**ElectraNet Revenue Determination:
Technical Review**

**Further advice on ElectraNet's
Revised Revenue Proposal**

**Report to
Australian Energy Regulator**

FINAL April 2013

Figure 1: Ratio of Cost Outcomes on Current ElectraNet Projects

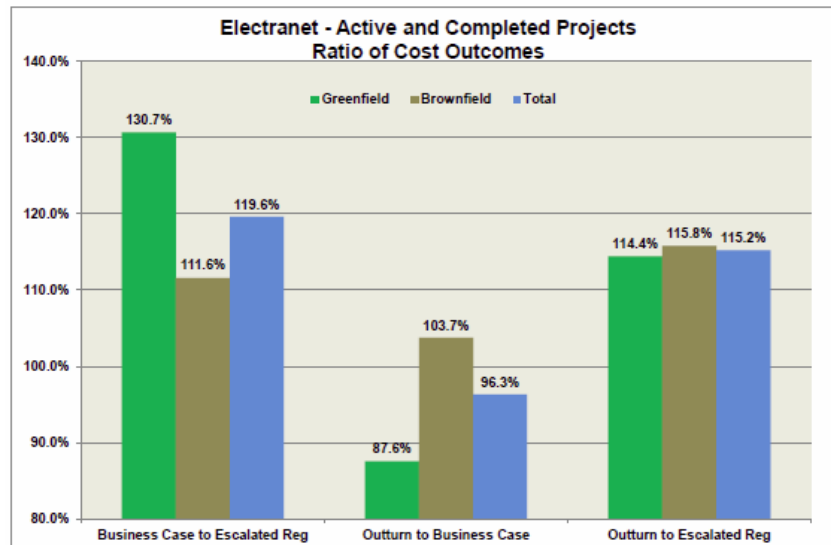
209. Evans and Peck state that the data indicates that risks in brownfields projects emerge “in the delivery phase rather than the planning phase, [but] the net effect is similar to that for Greenfield projects”.⁴⁰ They also note the greater cost overruns present in brownfields projects.
210. Evans and Peck also state that, because the Portfolio Risk Factor is established on a whole of portfolio basis it is “numerically incorrect” to apply it to only one component of the portfolio, such as greenfields projects. Also that it is not appropriate to compare risk factors from other transmission network service providers or other time periods as the capital spending programmes for those TNSPs or time periods are likely to be different.

211. EMCa has been provided with the data that we are informed was used by Evans & Peck in arriving at its proposed requirement for a 4.9% cost risk factor to be applied. Evans & Peck’s report explains the methodology used to derive this estimate and ElectraNet arranged for a representative from Evans & Peck to provide further explanation.
212. Central to Evans & Peck’s analysis is the assumption that the base planning object (BPO) costs used by ElectraNet for individual project costing are the “most likely”

213. While this is mathematically correct, it has not been demonstrated that the BPO costs used by ElectraNet are in fact P50 cost estimates in a strict sense, and despite the label applied to them. ElectraNet has explained to us that the BPO costs are calculated from actual costs of projects undertaken and as such represent competitive costs for such projects.

215. We reviewed the data used by Evans & Peck. First we observe that there are only 29 projects in the dataset for which there are actual costs to compare with the estimated costs⁴². We observe that only 3 of these projects are labelled as augmentation and connection projects and 4 are labelled as replacement projects. The remaining 22 are either security/compliance projects, or are un-categorised⁴³. Evans & Peck state that ElectraNet added a further 32 projects for which there was not a final cost, but for which ElectraNet considered that it had a sufficiently final estimate that it could be treated as an actual cost. These estimate components that were used as “actual” costs were provided by ElectraNet and were accepted without review by Evans & Peck, for its analysis.

Figure 2: Substations defects (Active)

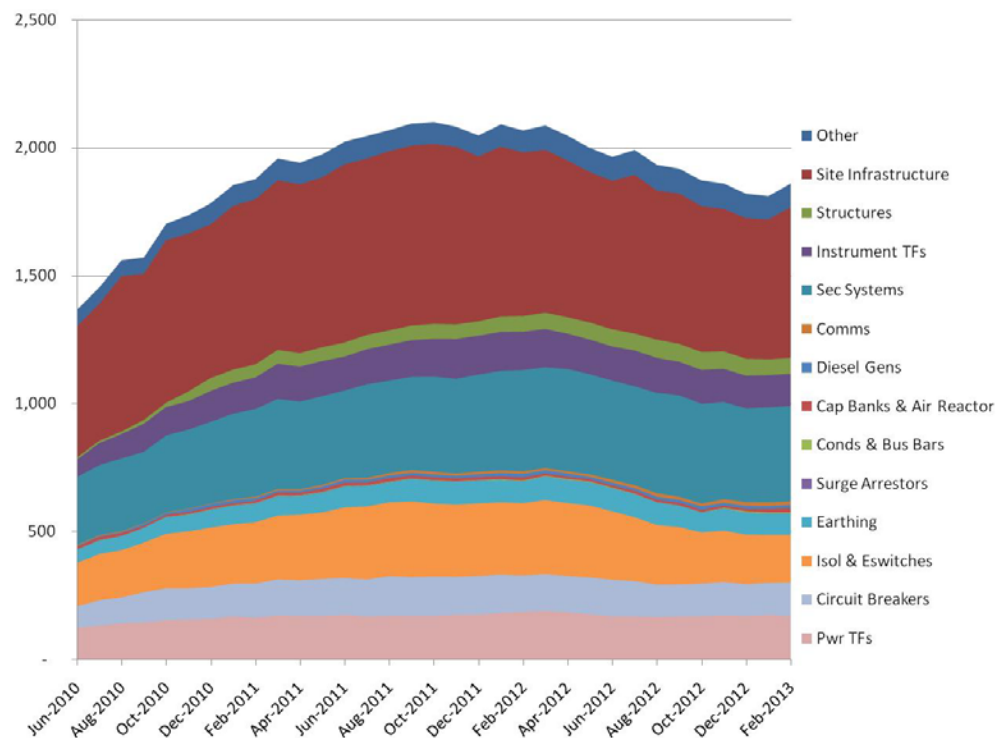
438. The following table shows the nature of “active” substation defects over time, by the nature of the defect. An increase indicates that ElectraNet is deferring corrective work.

439. In broad terms it can be seen that ElectraNet is correcting defects involving power transformers and CBs at approximately the incoming rate. A large proportion of the defects relate to “site infrastructure”. It can be seen that the “stock” of active defects has been decreasing since around October 2011, due to the level of corrective maintenance being applied.

Figure 3: Substations defects (New)

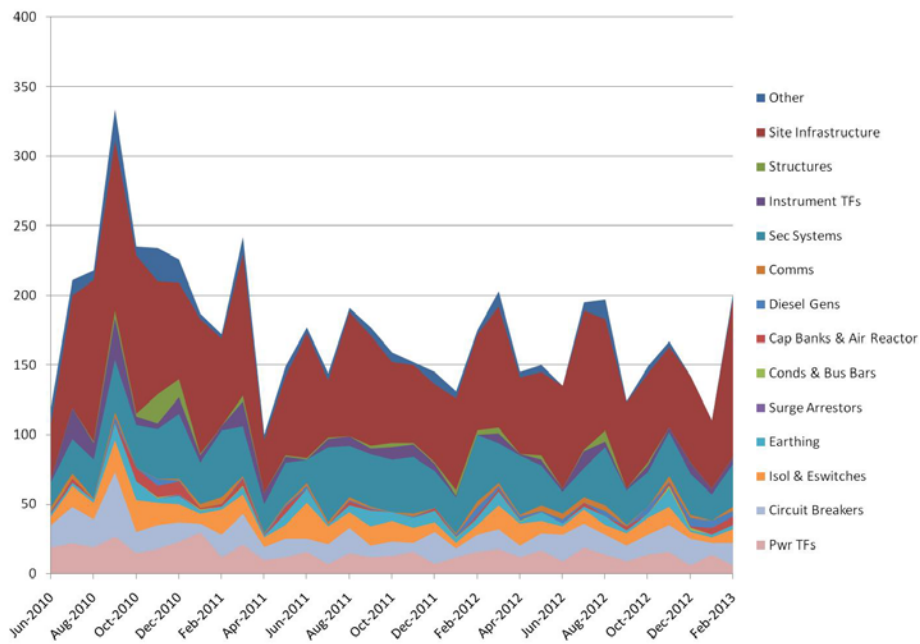
440. The following graph shows new substation defects. It can be seen that the initially high rate of incoming defects declined by around April 2011 and has remained static or declining since then. New defects relating to the main equipment (power transformers and CBs) are a relatively small proportion of overall new defects, and are also declining.

Figure 4: Lines defects (Active)

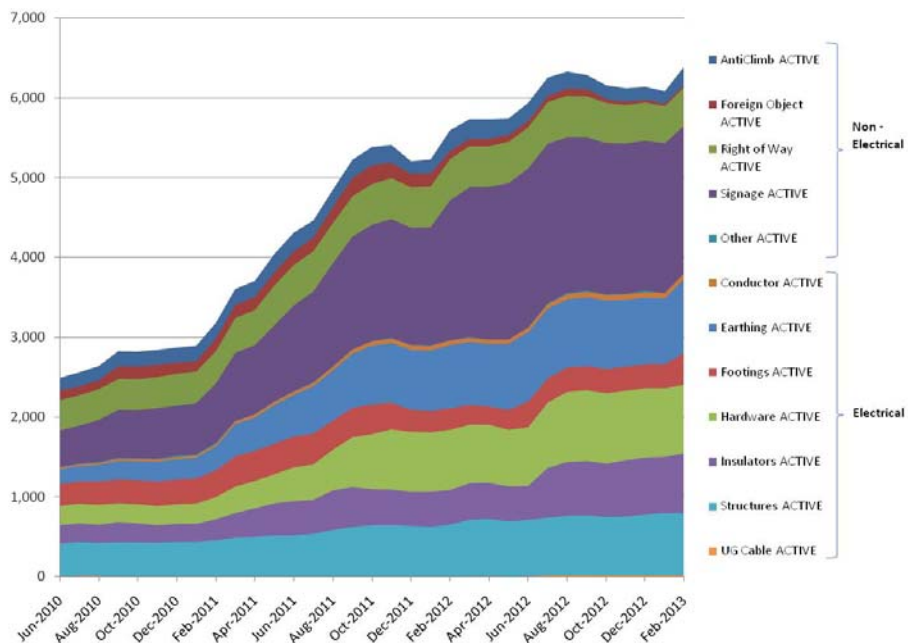
441. Then following table shows the nature of “active” lines defects over time, by the nature of the defect.

442. It can be seen that ElectraNet corrected lines defects over this period at a slower rate than incoming defects. The largest component of total defects is “signage”.

Figure 5: Lines defects(New)

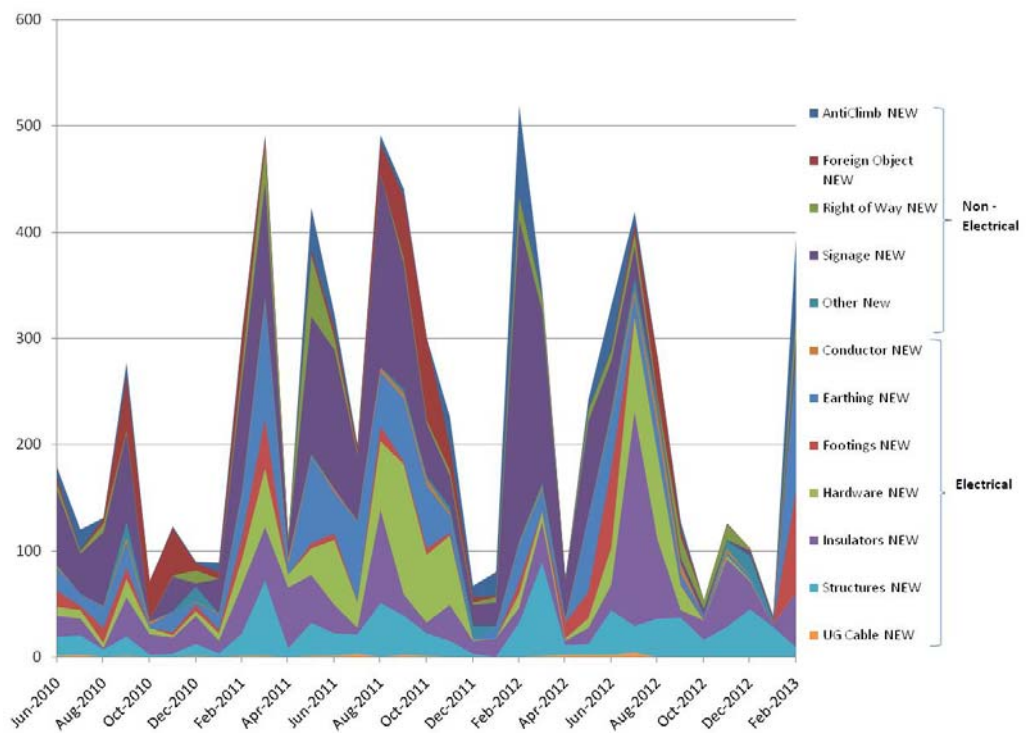
443. The following graph shows new incoming lines defects. Lines condition assessment is less far advanced than substations assessment; nevertheless the beginning of a reduction in the rate of incoming defects can be observed, from about April 2012. .
